LEGACY TRAILS
 PLANNED UNIT DEVELOPMENT
 PRELIMINARY OVERALL AREA DEVELOPMENT PLAN
 POADP NO. 401

RE: Revised Legacy Trails PUD Subdivision POADP #401

RE: Hill Country Resort Estates PUD Subdivision POADP #401

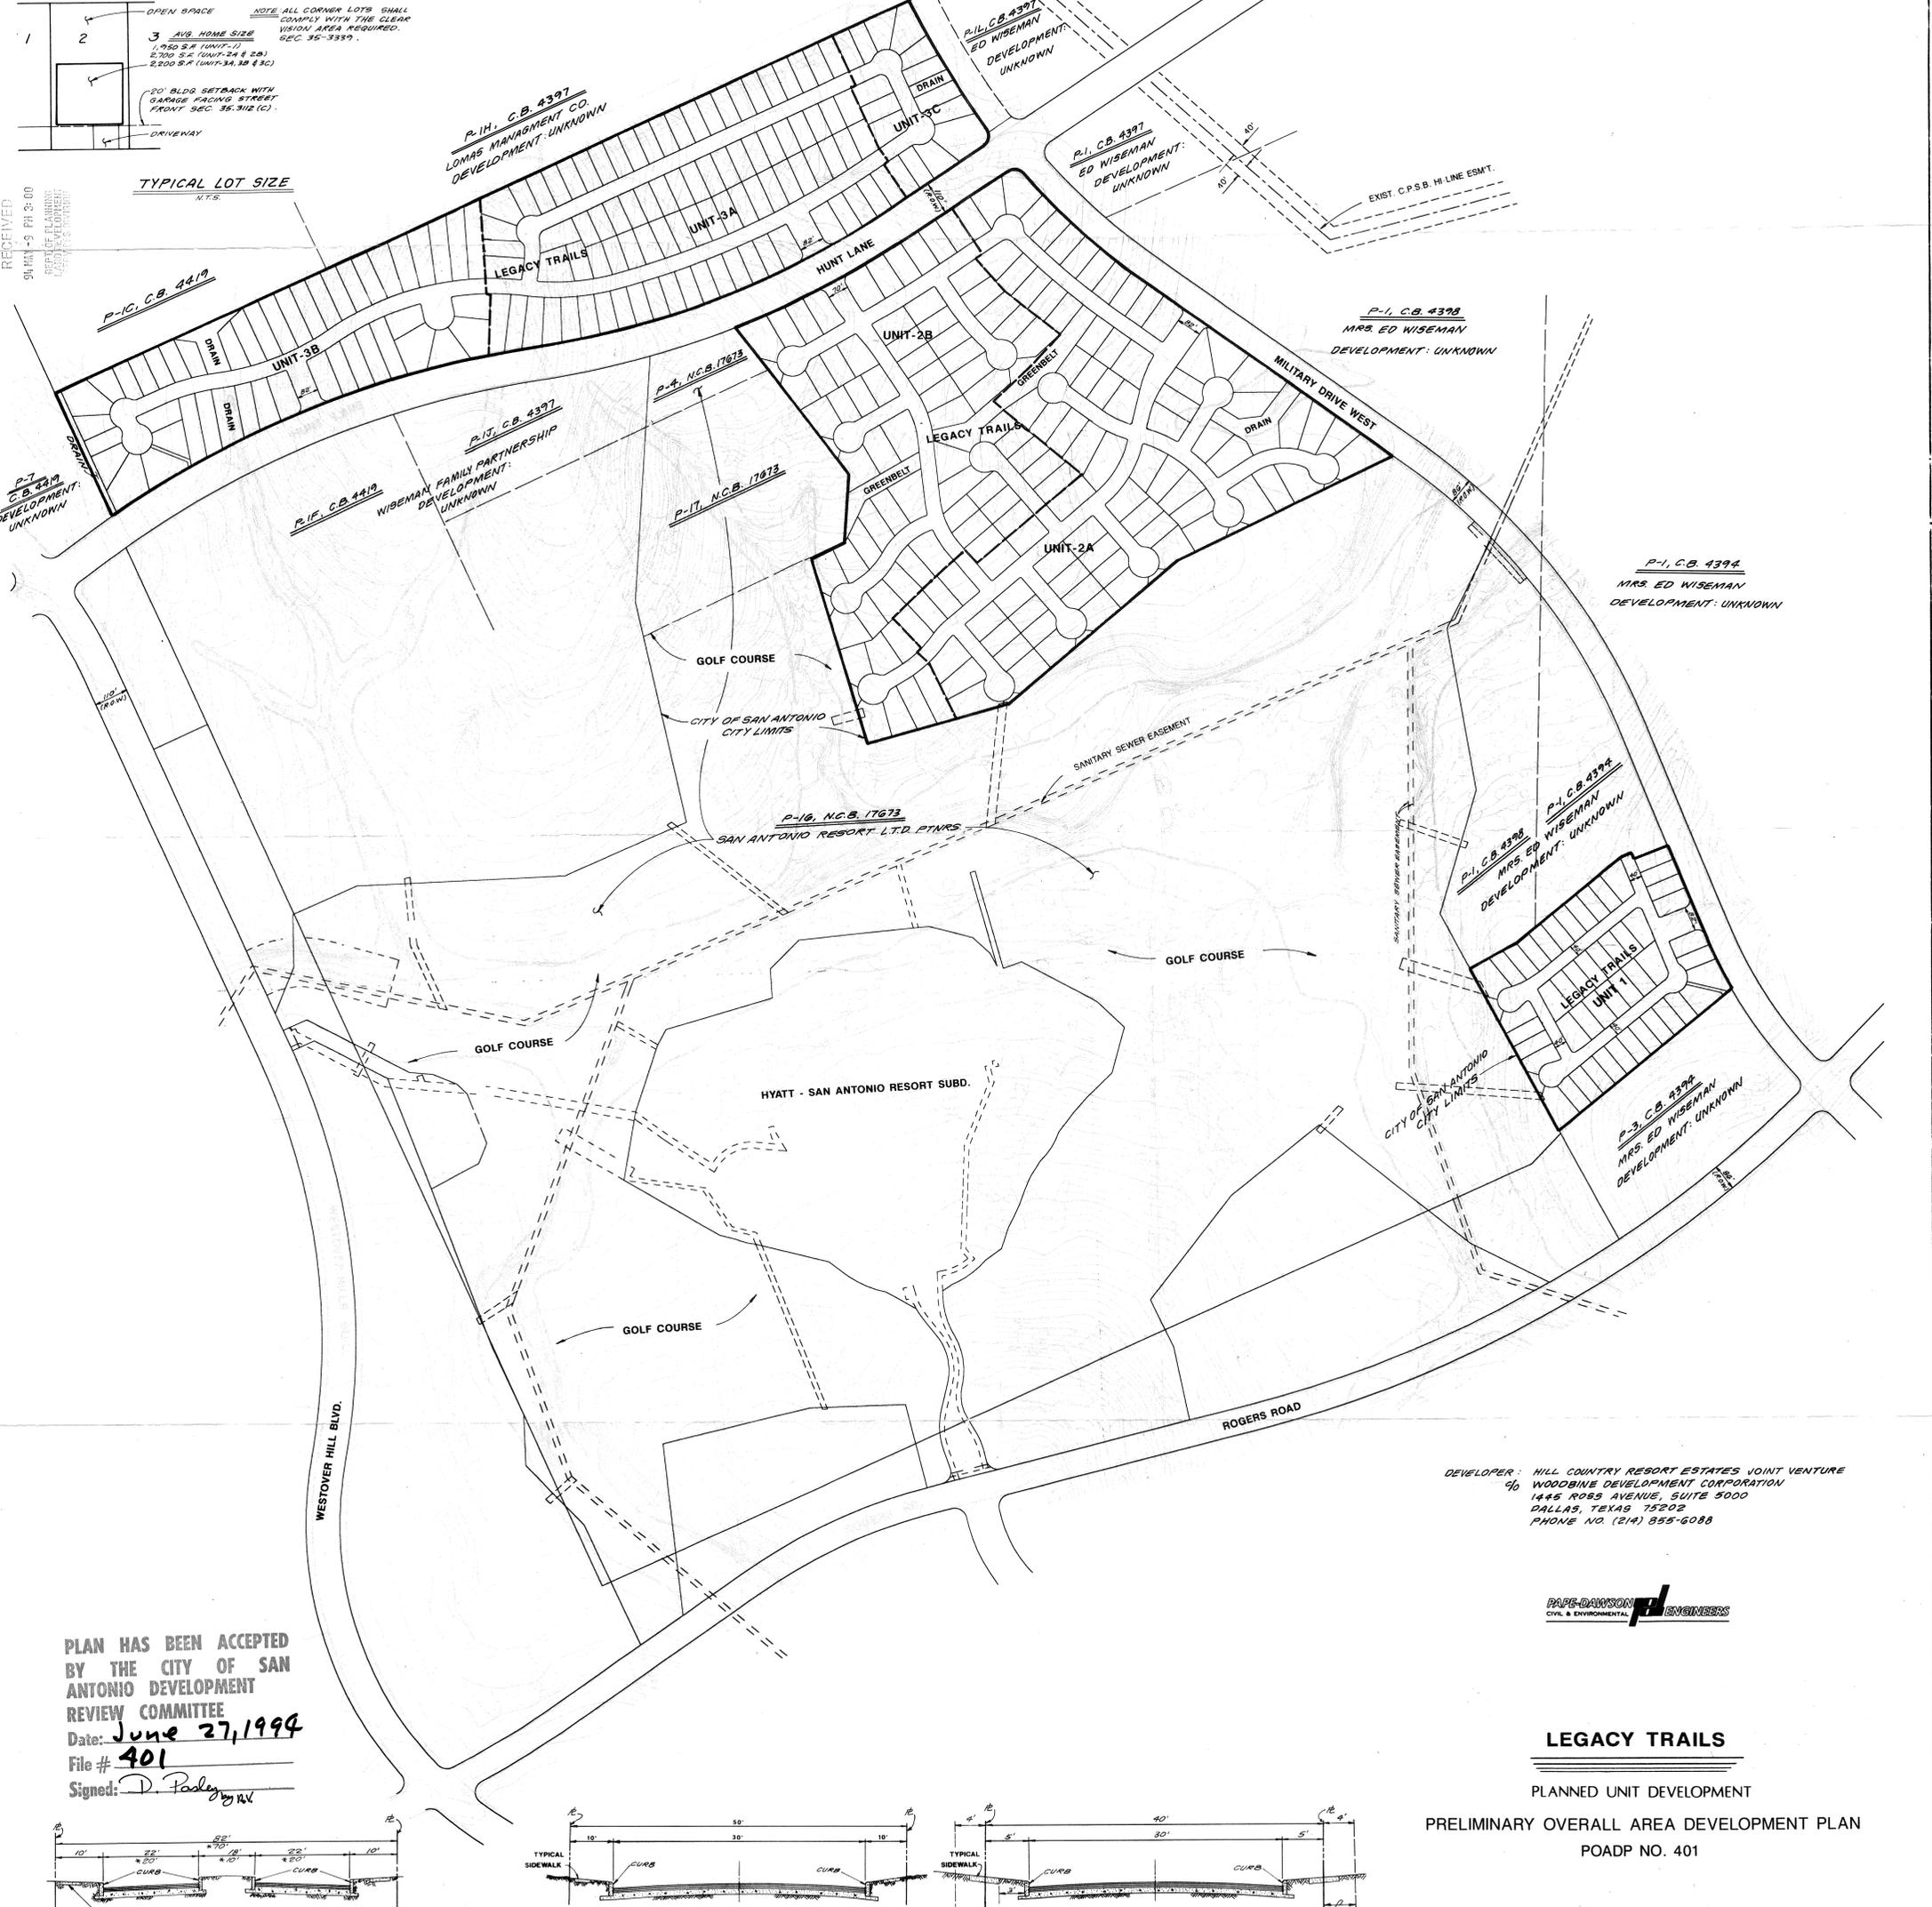
1. Platting, dedication, and construction of the extension of Military Drive West will be required in conjunction with the platting of Unit-3C.
2. A non-access easement will be required along the rear of all residential lots along Military Drive West and Hunt Lane at the time of plat submittal.
3. The Traffic Planning Engineer needs to review the gate detail to determine potential stacking problems.

1. Platting, dedication, and construction of the extension of Military Drive West will be required in conjunction with the platting of Unit-3C.
2. A non-access easement will be required along the rear of all residential lots along Military Drive West and Hunt Lane at the time of plat submittal.
3. The Traffic Planning Engineer needs to review the gate detail to determine potential stacking problems.
